SUBJECT: Forwards responses to questions re 840402 application for amend to License DPR-18. Six proprietary oversize drawings encl. Aperture cards available at Central Files.

Subject: Responses to NRC Staff Questions
R. E. Ginna Nuclear Power Plant
Docket No. 50-244

Attached are responses to NRC Staff questions concerning our
Application for Amendment to Operating License of April 2, 1984.

FIGURE 1 :

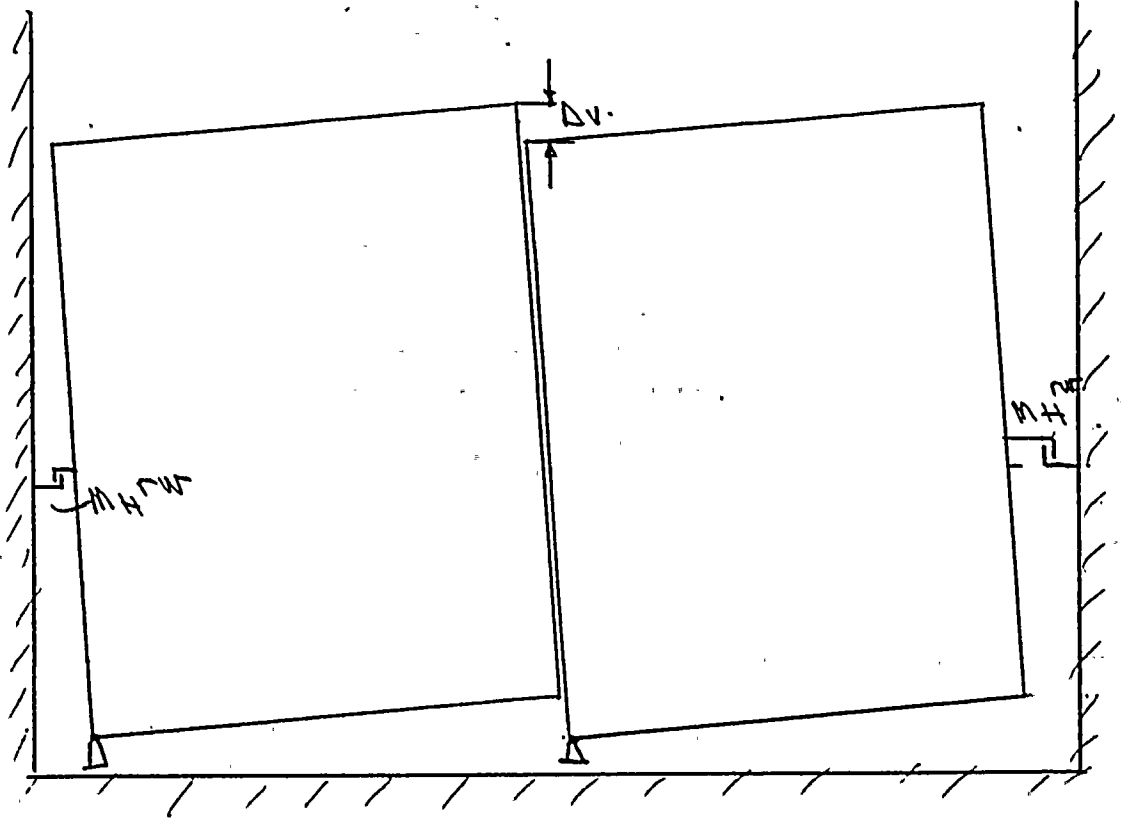
- a. Explain how the 2-D RACKOE model can be used to simulate the 3-D nonlinear structural behavior exhibited by the rack.
- b. Discuss why the nonlinear behavior of friction between the rack and the support stand was not included in the model.
- c. Explain how the model can be used to simulate a partially loaded rack.
- d. There is only one hydrodynamic coupling mass between rack and fuel assembly as well as rack and wall. Discuss the effect of having five such masses in the model open the analysis results.
- e. Elaborate on the procedure to include the gap between adjacent racks in the evaluation of hydrodynamic coupling mass between rack and wall.

2e). The water in the rack - rack gap acts to force the racks in line to move in unison. If two racks were included in the model, they would be coupled to each other in the same manner the fuel is coupled to the racks, i.e., using hydrodynamic masses. Using case #13 from Fritz: $M_H = \rho b^3 / 12S$, a 1" gap results in $M_H = 1.03 \times 10^6$ lbs. Since the racks are installed with a nominal zero gap, the actual hydrodynamic mass is much larger, virtually tying one rack to the other horizontally. The hydrodynamic mass does not, however, force the two racks to act compositely as a single rack, since the fluid cannot transmit the required shear. Rather, the movement is as shown on Figure 1, with one rack end displacing vertically with respect to the other at the interface.

FIGURE 2

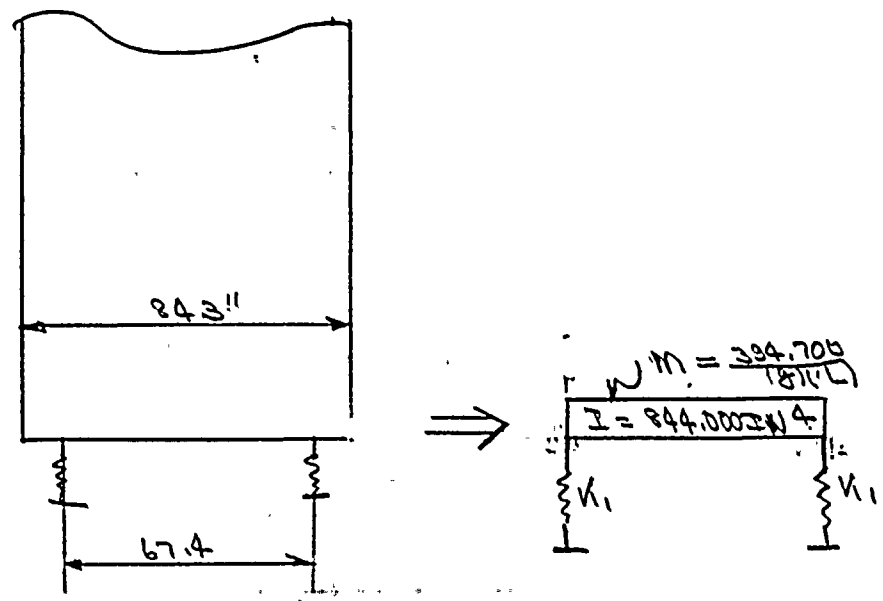
3. In the RACKOE model for liftoff analysis, please response to the following:
- a. A single mass node was used to represent the rack and its contents. Discuss whether this simplified model is adequate to produce conservative results.
 - b. Indicate whether the following multiplication factors for seismic loads were used in the analysis:
 - 1.1 for SSE
 - 1.5 for OBE
 - c. Discuss whether this 2-D model is capable of simulating all possibilities of liftoff including the case of three supports off the pool liner.

The first element considered is a simply supported beam of distributed mass and stiffness (see figure 2). From Biggs,

page 154 $f = \frac{W}{2\pi} = \frac{\pi}{2L^2} \sqrt{\frac{EI}{M}}$. I is the moment of inertia of

of the rack, with height 159 inches and width of 14 boxes. I

$= 14 (.18) (159)^3 / 12 = 844.000 \text{ in}^4$. L is the span length - taken as 67.4 inches in the east - west direction. The mass $M = 394.700 / (84.3)g = 4682/g \text{ lb/in}$.

$$f = 483 \text{ CPS}$$

ACCELERATION TIME HISTORY

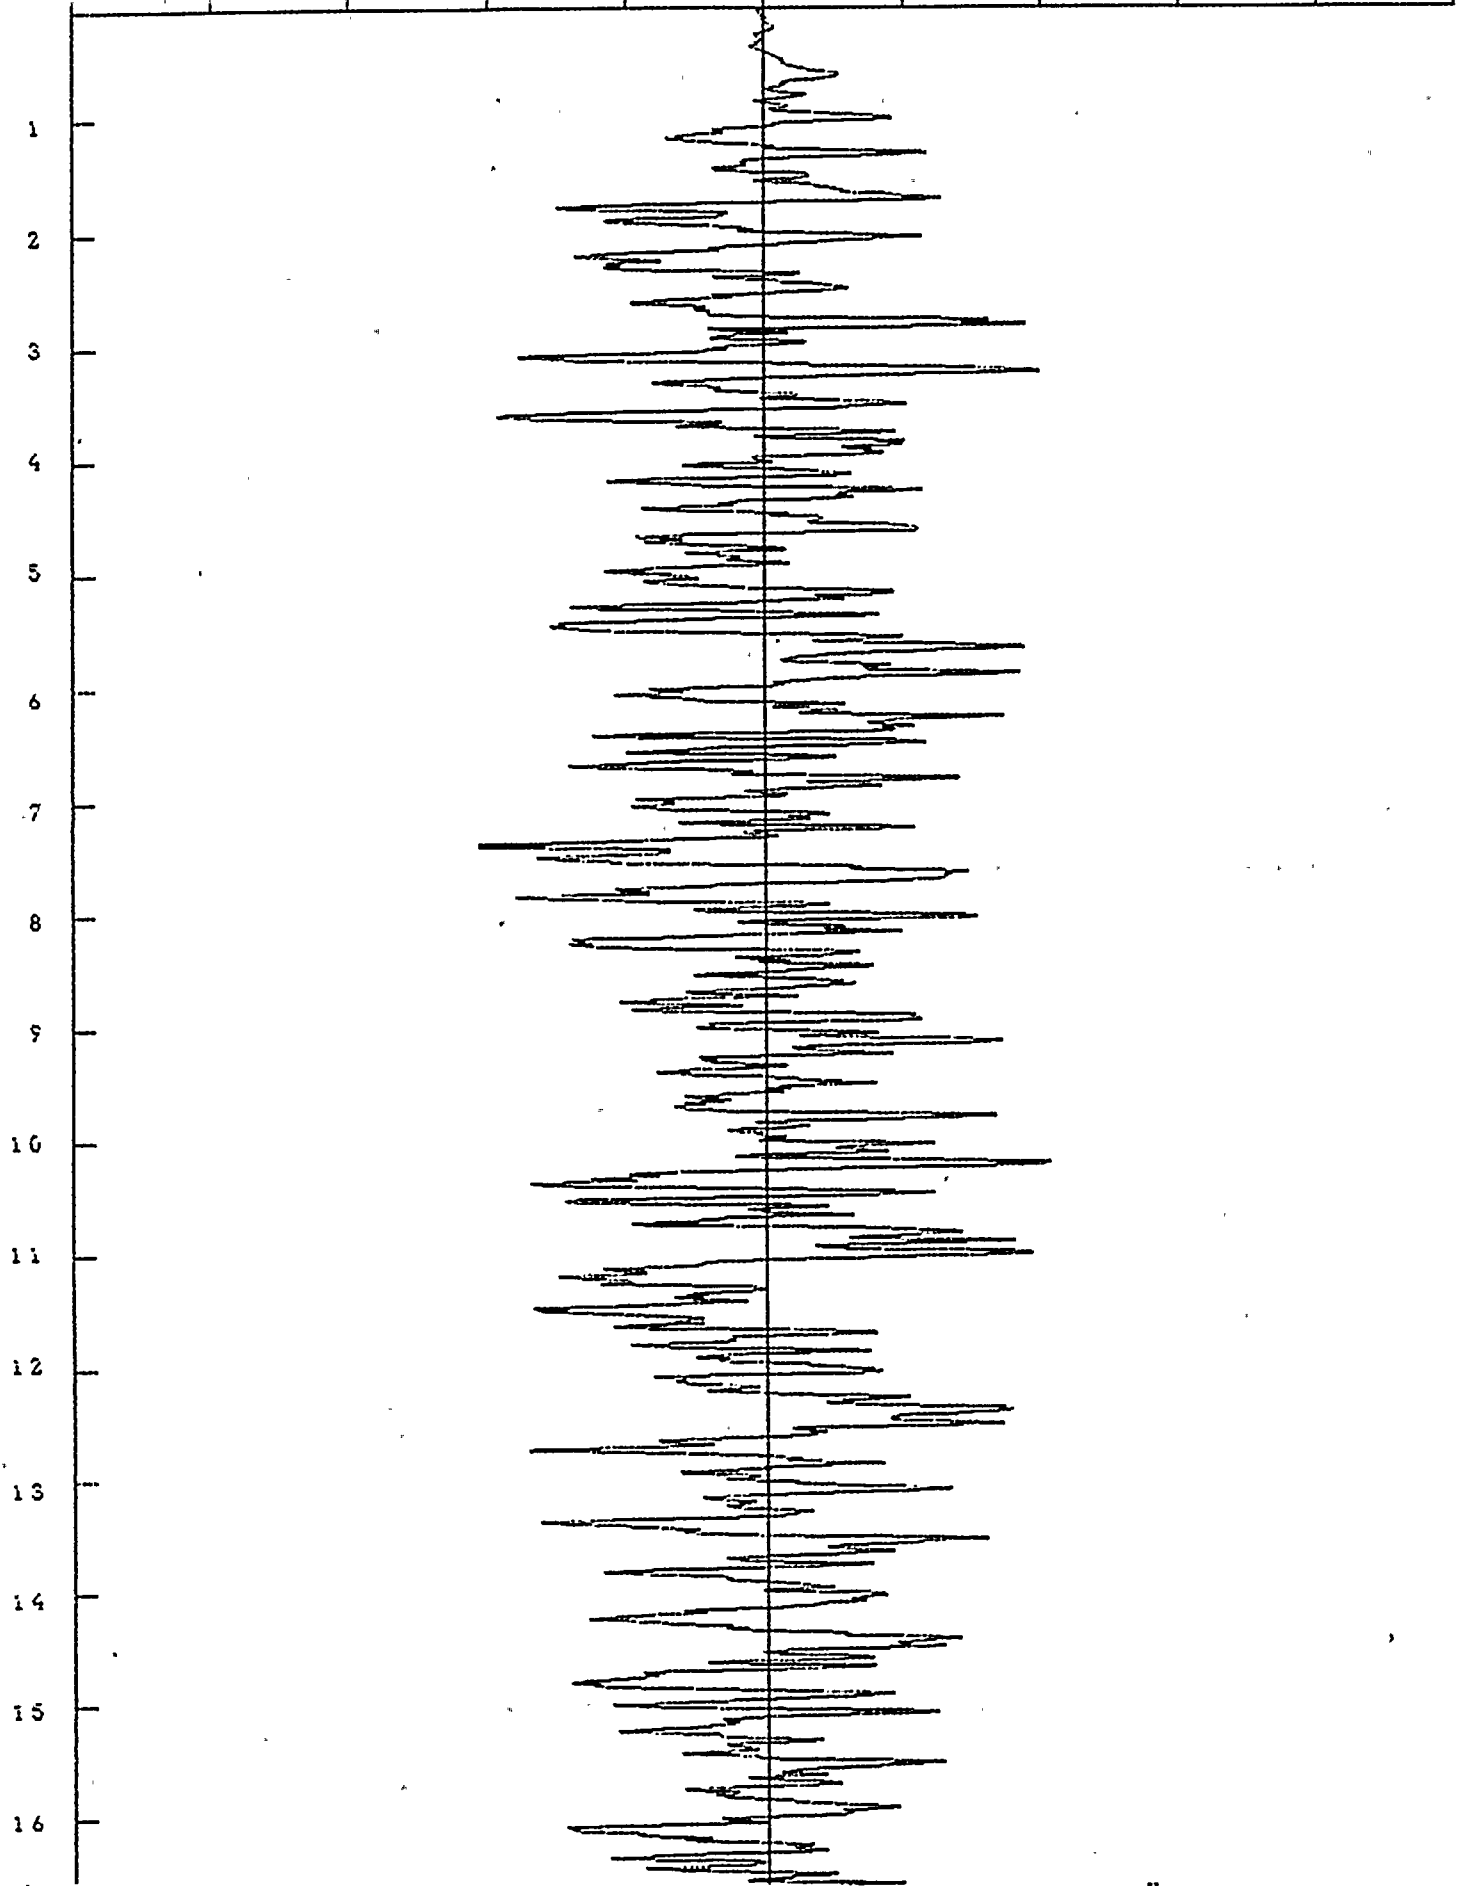
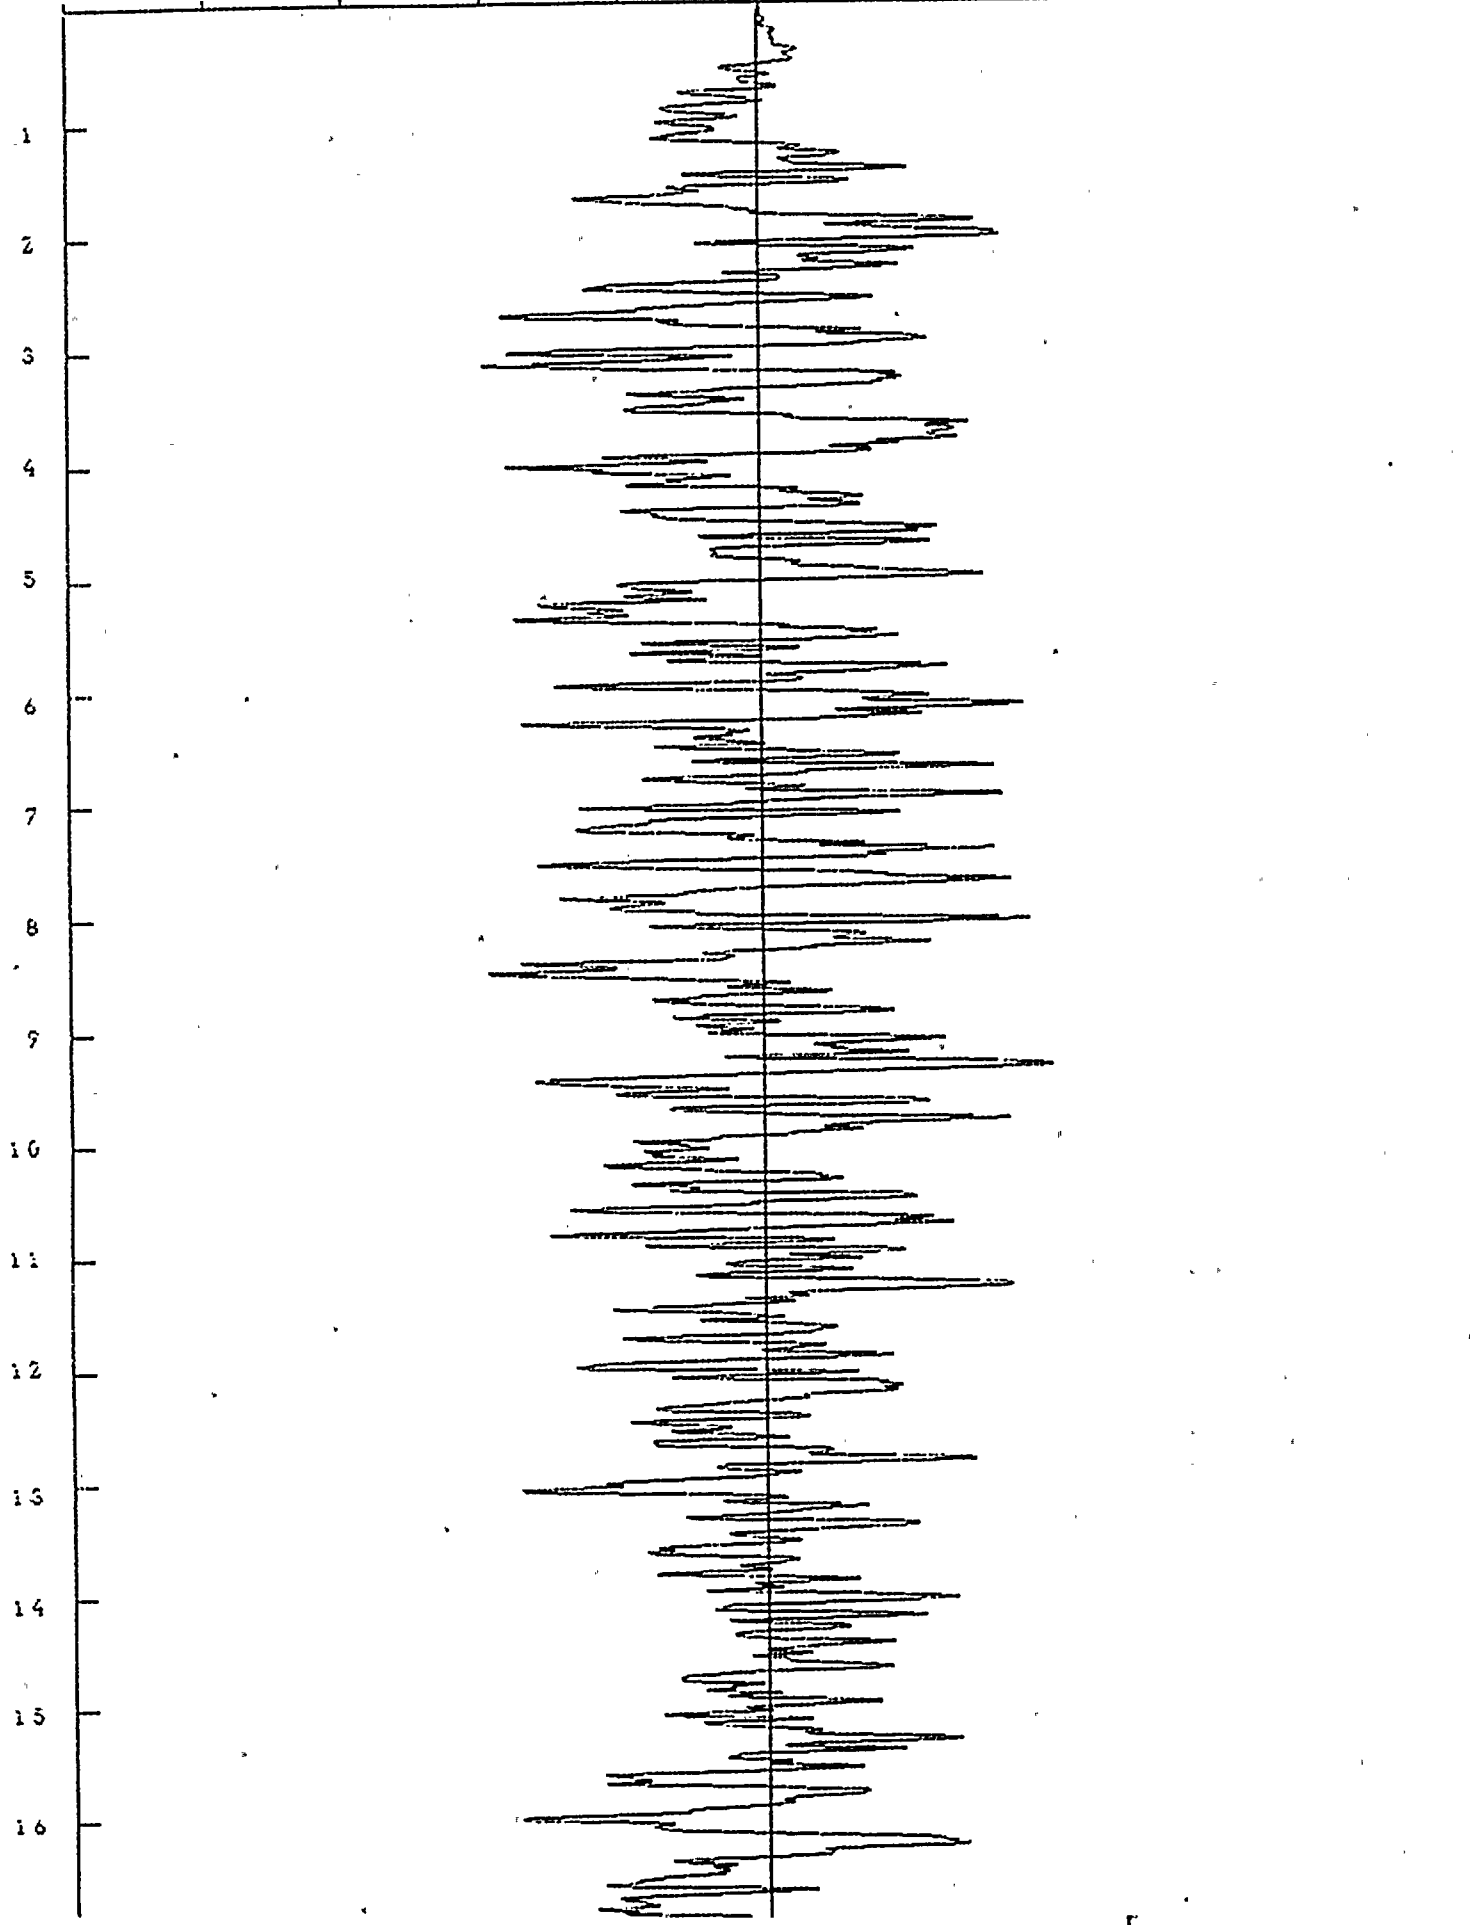
6. Please provide the E-W and N-S time history plots used in the seismic analysis.

The time history plots are attached.
